Sniped stiffeners, requirement to buckling capacity.

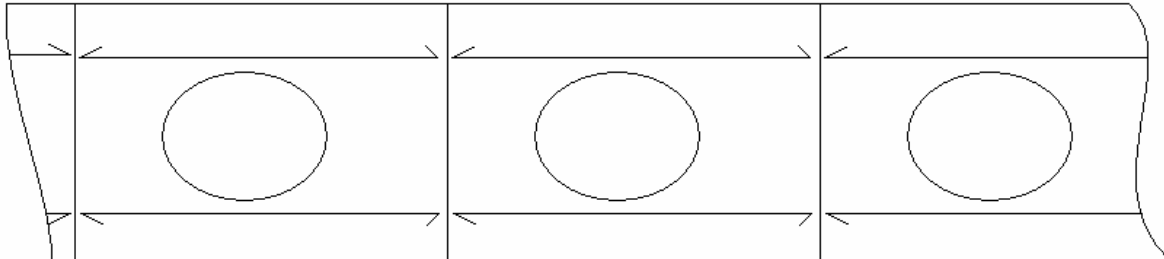
a) Please explain whether Ch. 6 Sec. 3.4 is applicable to e.g. the sniped flat bars of a longitudinal double bottom girder as shown below.

b) Ch. 6 Sec. 2 is giving minimum requirements to ordinary stiffeners. Please advise if this requirement is applicable to sniped buckling stiffeners as shown above.
